645-017-11

ADDENDUM NO. 2

Wayne State College
Carhart Building Phase III
Wayne, NE
TCEP No.: 645-017-11

A
002

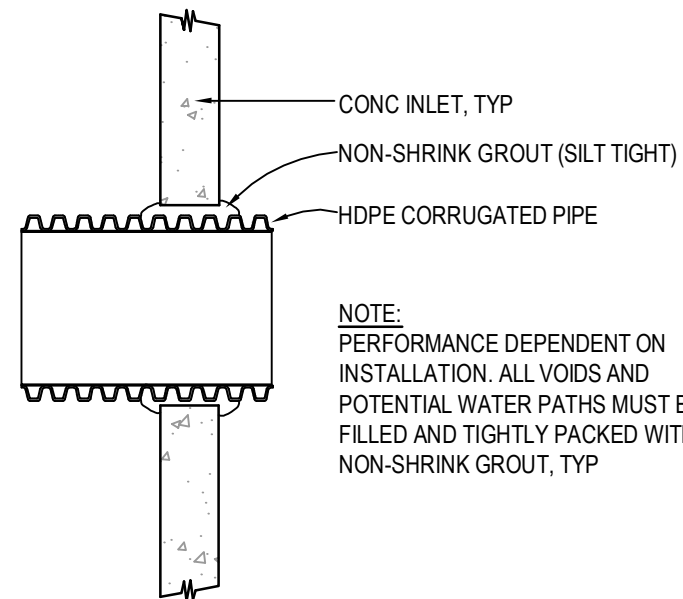
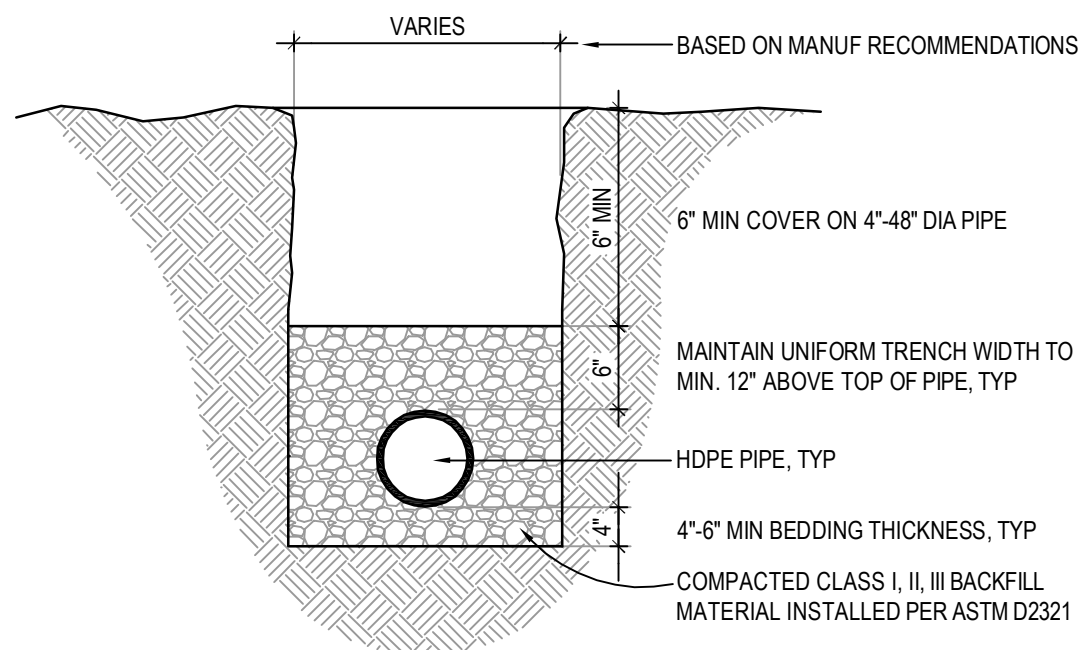
Refer to Site Details. Add additional storm drainage pipe details. Reference SDL-002

Addendum #02
Supplemental Drawing: SDA-001A
Revision of Detail: 14/LF2.2
Date: April 9, 2012

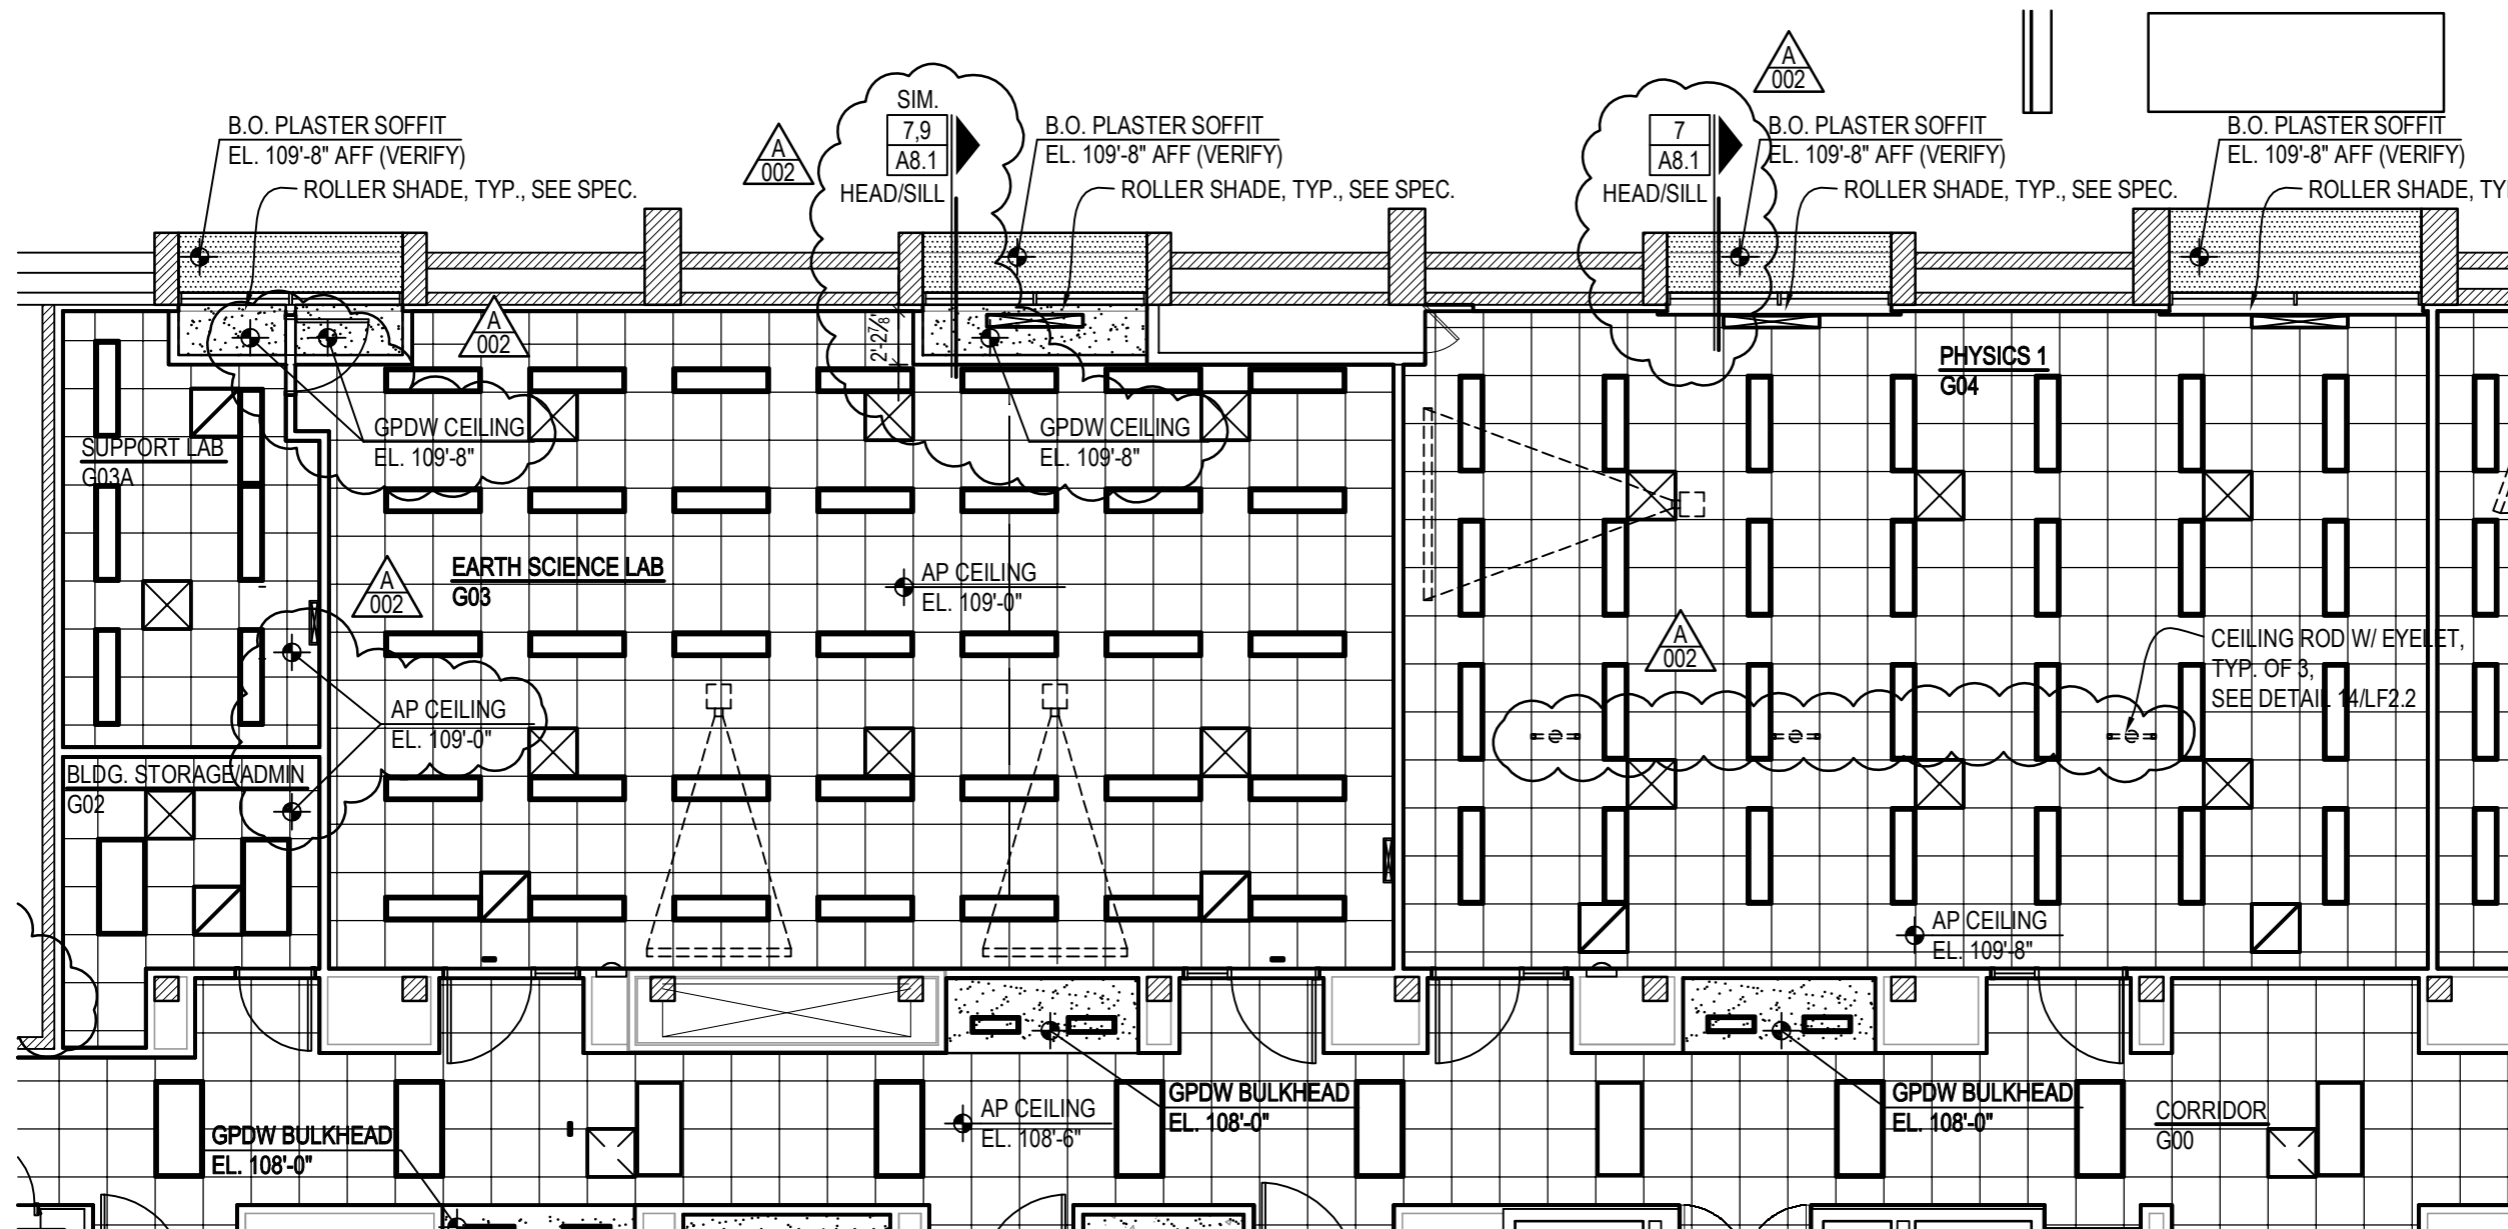
See supplemental drawing SDA-001A & SDA-001B.

Addendum #02
Supplemental Drawing: SDA-001B
Revision of Detail: 14/LF2.2
Date: April 9, 2012

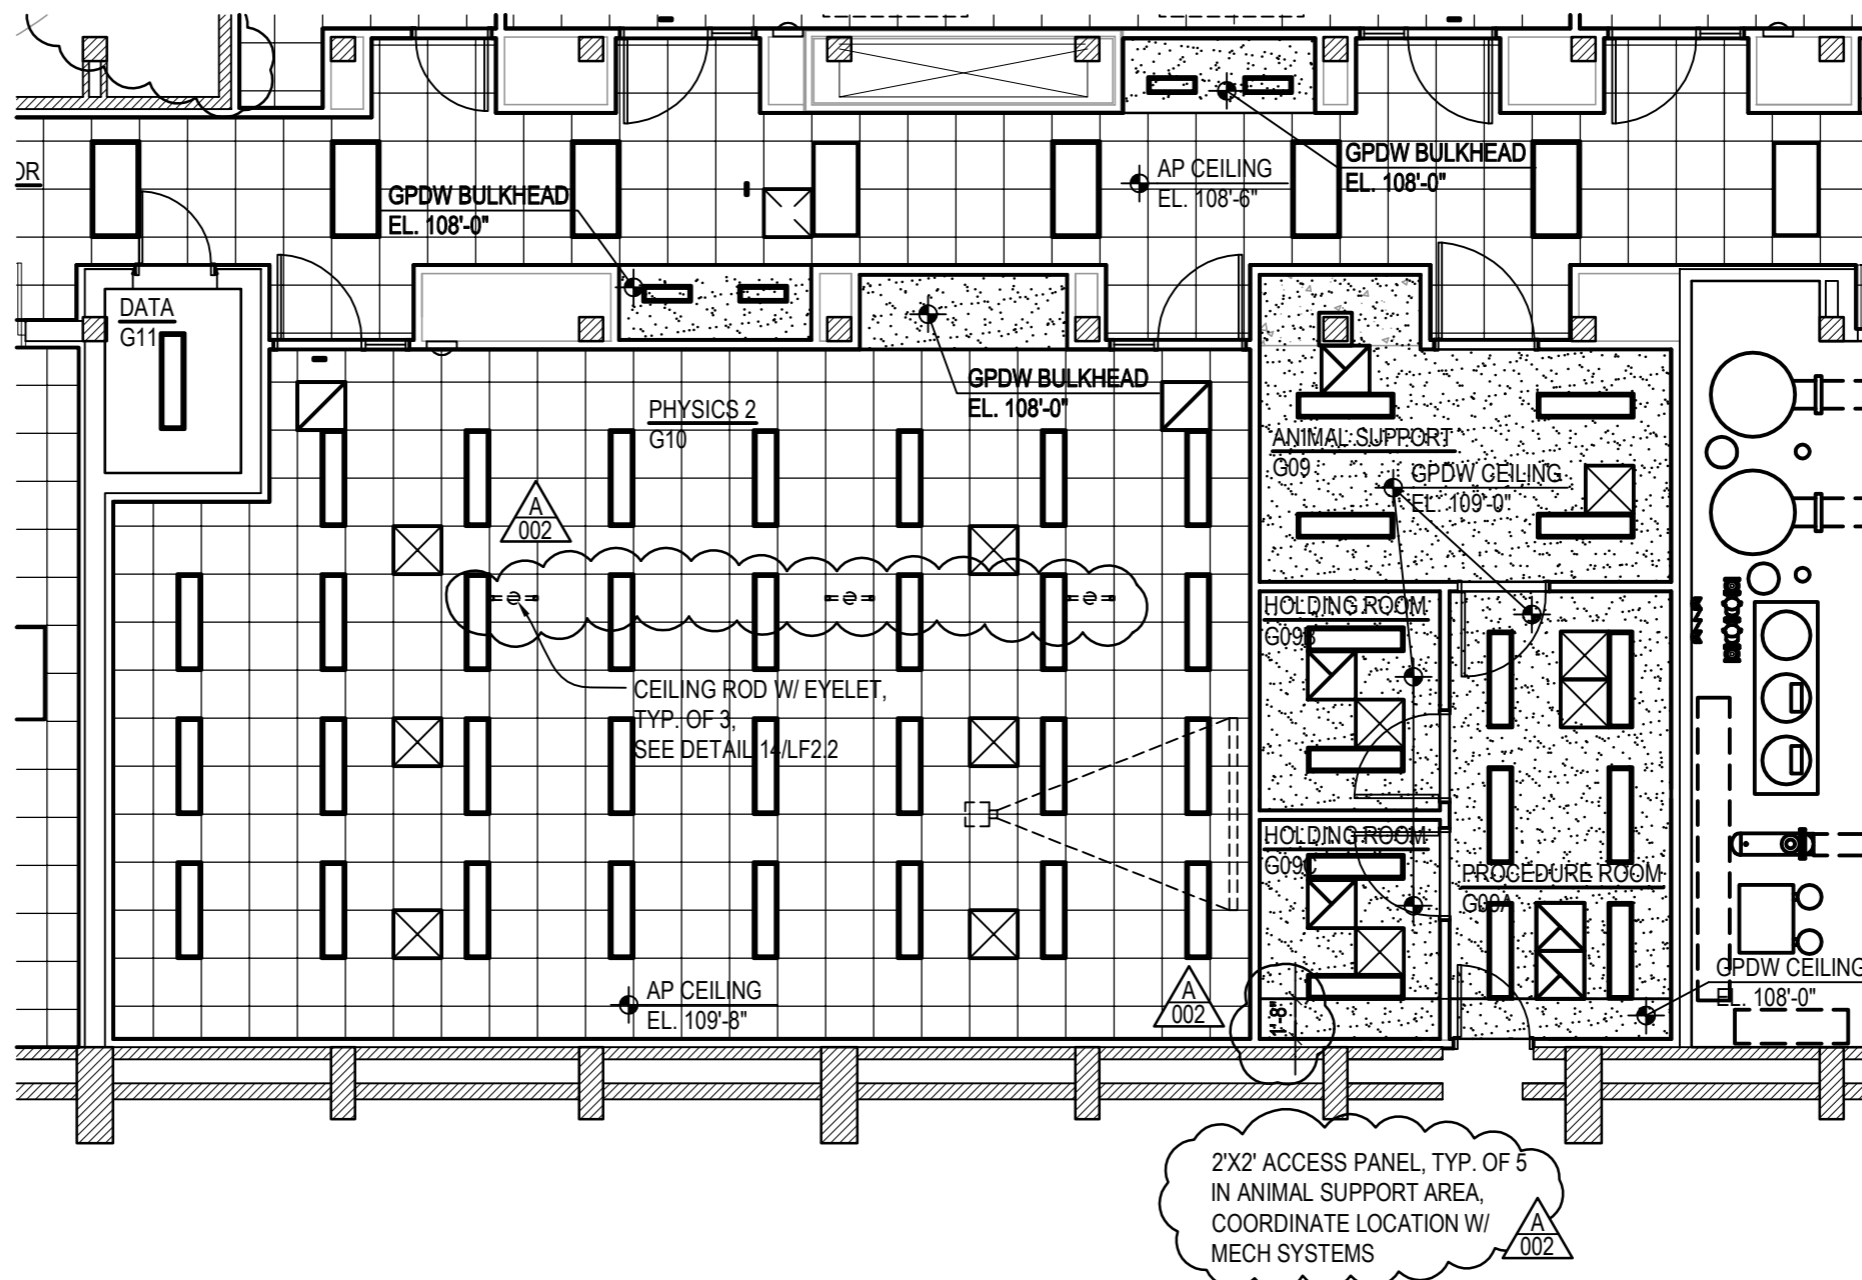
Location of ceiling rods will be located between lab tables and not over tables.
Physics 1 G04: Move rods over to the east. Physics 2 G10: Move rods over to the west. See supplemental drawing SDA-001.

Addendum #02
Supplemental Drawing: SDA-002
Revision of Detail: 14/LF2.2
Date: April 9, 2012

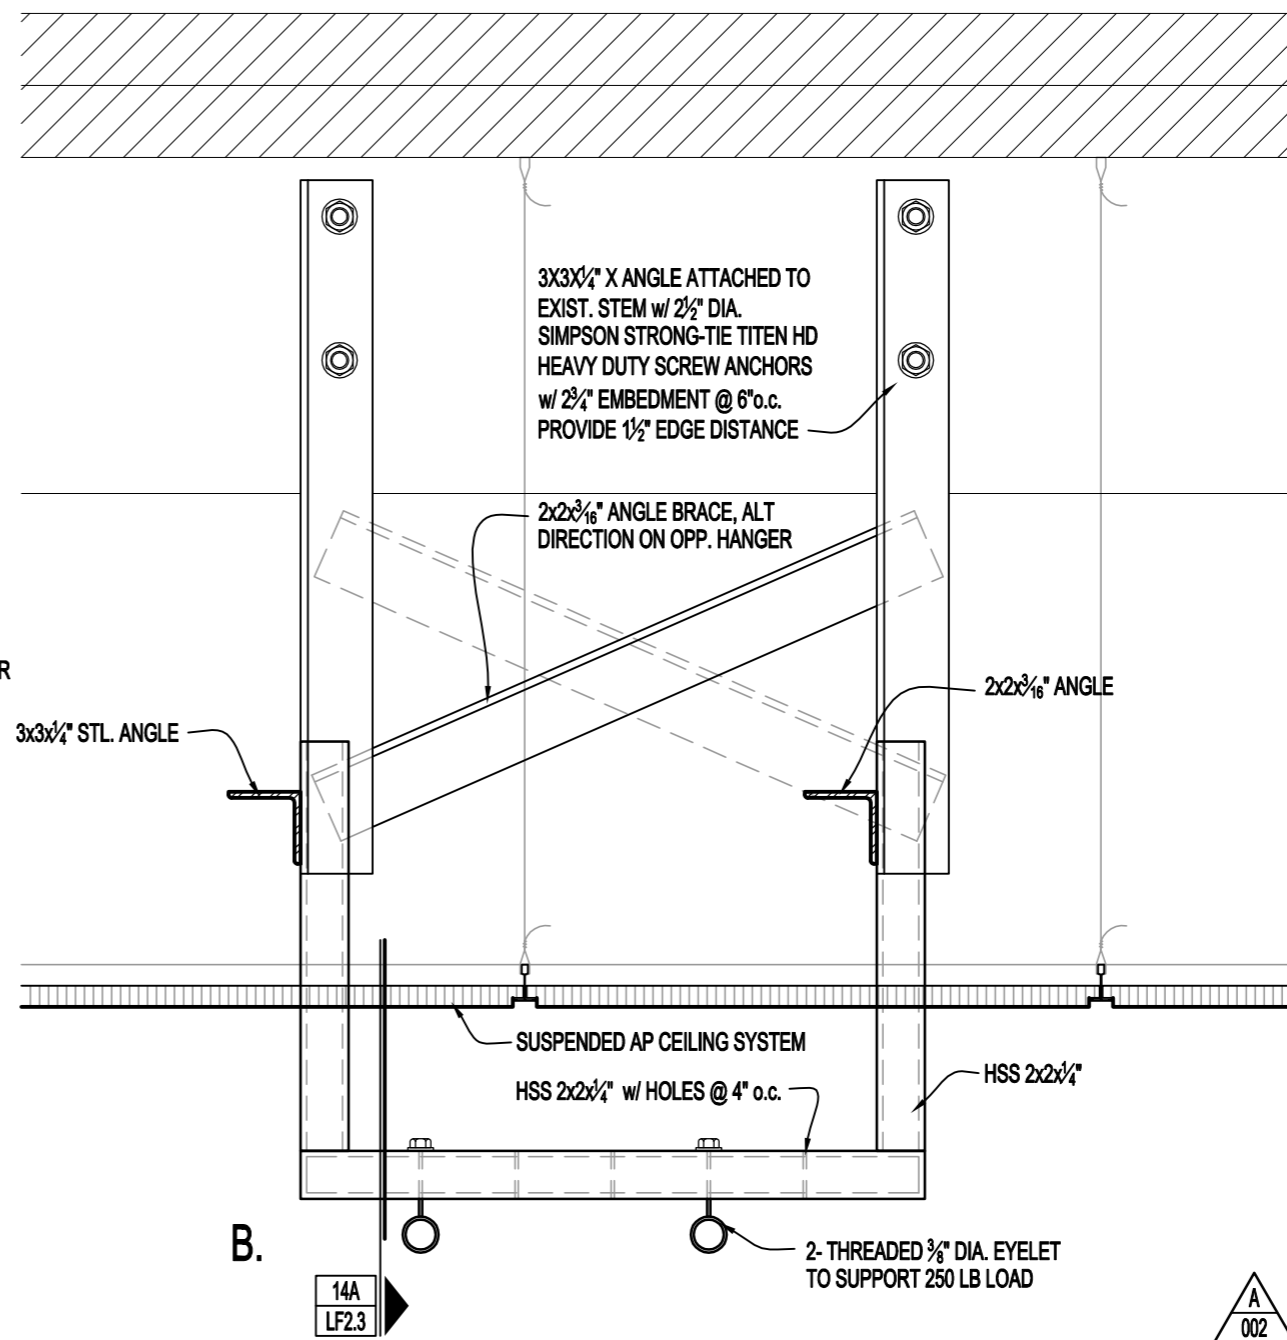
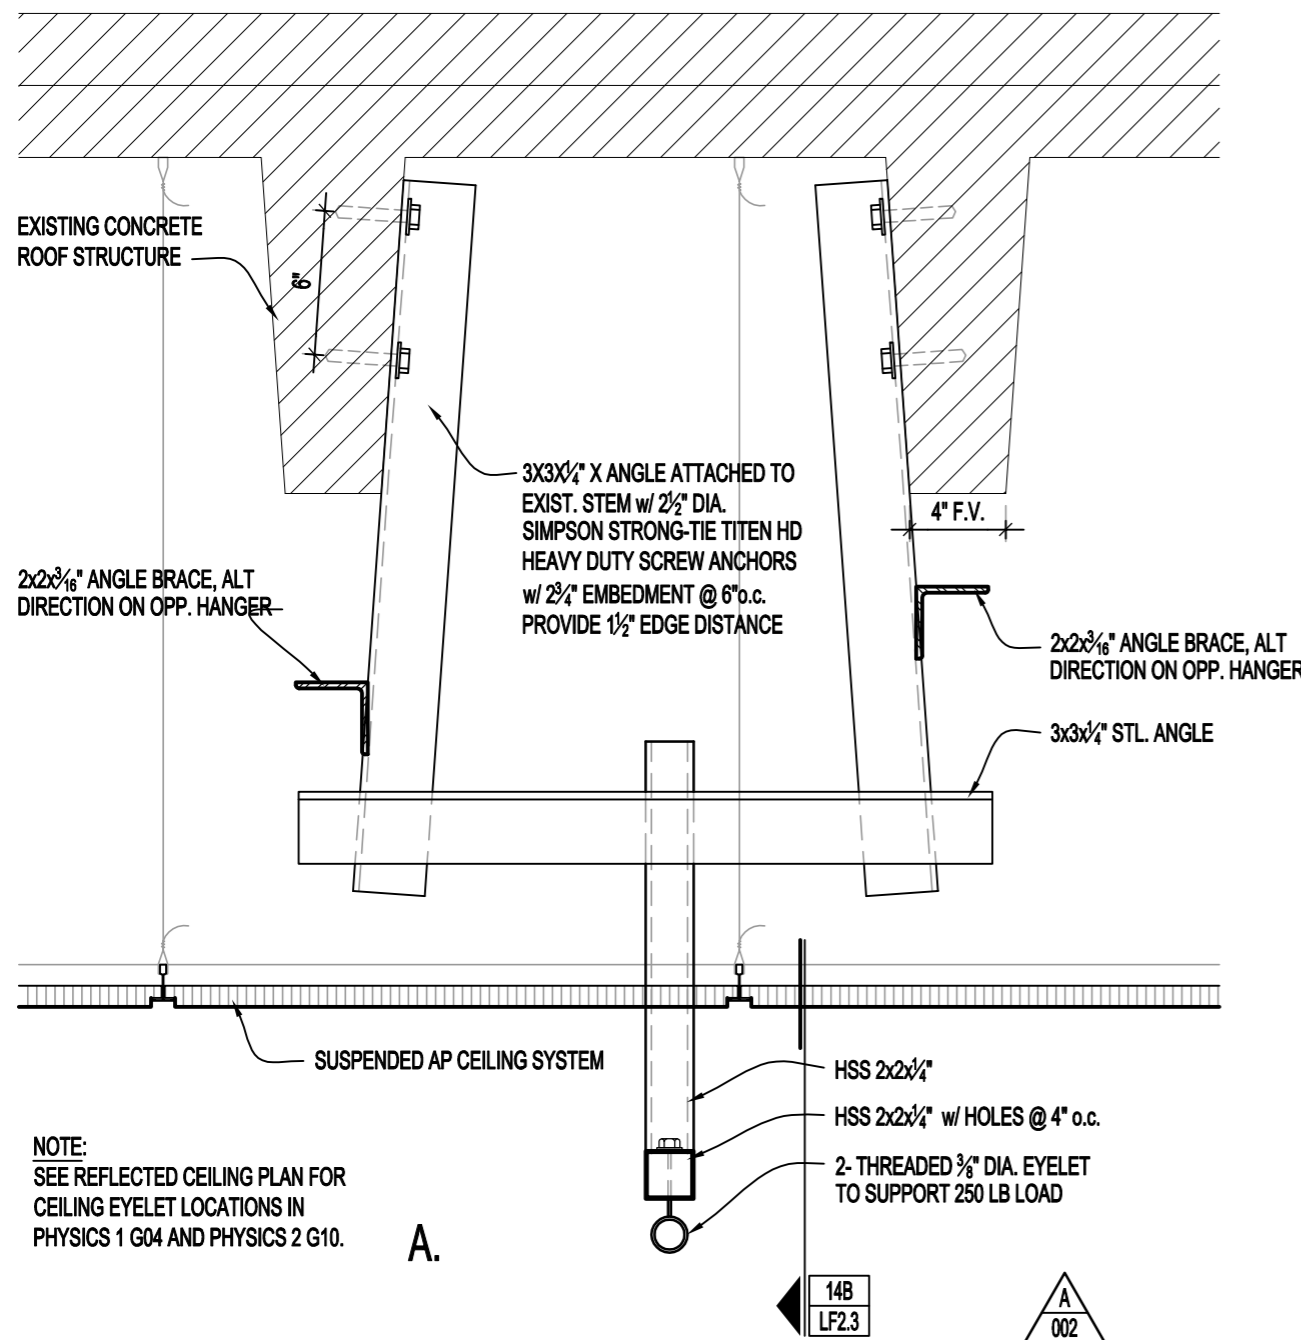
Modification and clarification to Detail 14/LF2.2. See supplemental drawings SDA-002.
